UNITED STATES PATENT AND TRADEMARK OFFICE

Office Action Summary

10/766,671

DETAILED ACTION

Peta, Figure 2

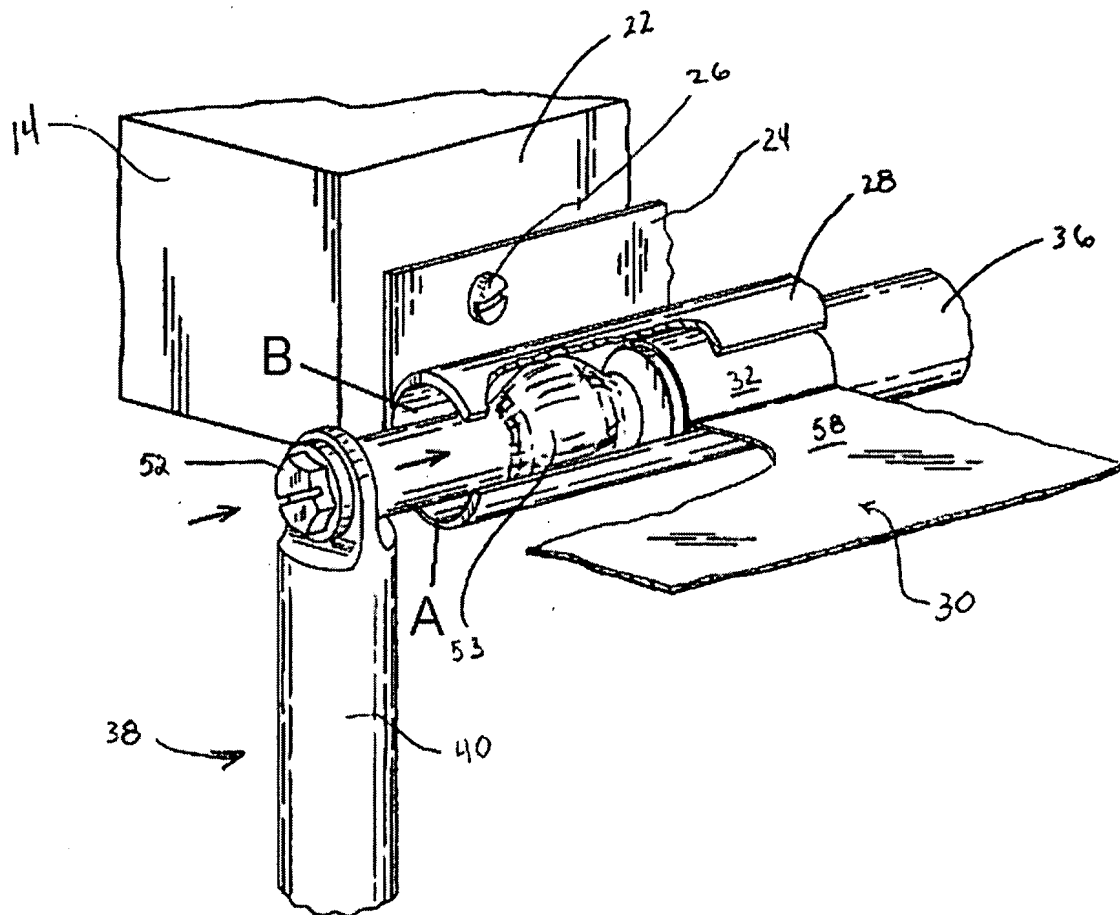
a. Regarding Claim 1, Peta teaches an apparatus for covering the rear of a golf cart, the apparatus comprising a U-shaped stationary frame member (comprising at least 40, 42 and A), a movable frame member (56), and a cover (58), the stationary frame member mounted on the golf cart by brackets (24), the brackets configured to attach to the golf cart at as support frame and roof (the brackets would attach to both the frame and roof if the golf cart was constructed

to have a support frame along the perimeter of the roof), each bracket is configured to be attached in at least two locations (the brackets have multiple mounting holes, best seen in Figure 3) and each bracket (24) is configured to be secured to the golf cart at the support frame and at the roof (the brackets would attach to both the frame and roof if the golf cart was constructed to have a support frame along the perimeter of the roof). Please note: limitations drawn to the golf cart or the combination of the golf cart and apparatus will be given no patentable weight, as the applicant has expressly stated (in Section V of the remarks submitted on 9/27/07) that the claims are directed to the "subcombination of an apparatus..."

- b. Regarding Claim 3, Peta teaches that the stationary frame member comprises a U-shaped frame having a horizontal portion (A) and two legs (40, 42).
- c. Regarding Claim 4, Peta teaches that the horizontal portion (A) of the frame member is mounted to the brackets (24).

- d. Regarding Claim 5, Peta teaches that the movable frame member comprises a U-shaped frame with a horizontal portion (66) and two legs (70, 72).
- e. Regarding Claim 6, Peta teaches that at least one leg (70) of the movable member mounts to a respective leg (40) of the stationary frame member.
- f. Regarding Claim 7, Peta teaches a retainer bar strip (28) including a channel (B) and a retainer bar (36) wherein a portion of the cover (32) fits within the channel when the retainer bar is positioned within the channel.
- g. Regarding Claim 8, Peta teaches that the cover is sufficiently flexible ("pliable fabric cover 30" see Column 2, line 64) to extend from the retainer bar strip and over a portion of the rear compartment of the golf cart.
- h. Regarding Claim 9, Peta teaches a strap (76) configured to restrain the cover adjacent the stationary frame member.
